UNITED STATES PATENT AND TRADEMARK OFFICE

APPLICATION NO.	FILING DATE	FIRST NAMED INVENTOR	ATTORNEY DOCKET NO.	CONFIRMATION NO.
10/666,351	09/17/2003	Shmuel Shapira	SYM 306	8190
23581	7590	09/27/2005	EXAMINER	
KOLISCH HARTWELL, P.C. 520 S.W. YAMHILL STREET SUITE 200 PORTLAND, OR 97204			BOGART, MICHAEL G	
			ART UNIT	PAPER NUMBER
			3761

Office Action Summary	Application No. 10/666,351	Applicant(s) SHAPIRA, SHMUEL	
	Examiner Michael G. Bogart	Art Unit 3761

FIG. 1a

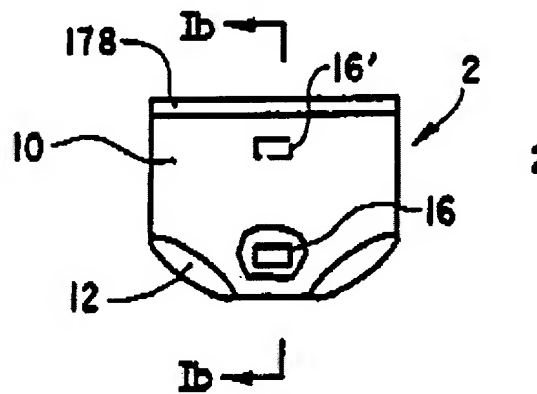
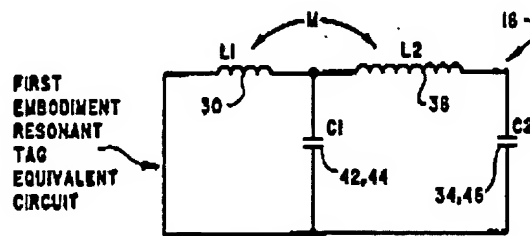
Regarding claims 1 and 36, Friedman *et al.* teach a urine detection network, comprising:

a first detector (16) configured to service a first region of a urine collection article (2);

at least a second detector (16') operatively coupled to the first detector and configured to service a second region of the urine collection article (2);

wherein the first detector (16) and the second detector (16') are collectively configured to indicate a fluid distribution of the urine collection article (2)(column 3, lines 31-56)(column 11, line 32-column 12, line 55)(see figure 1a, below).
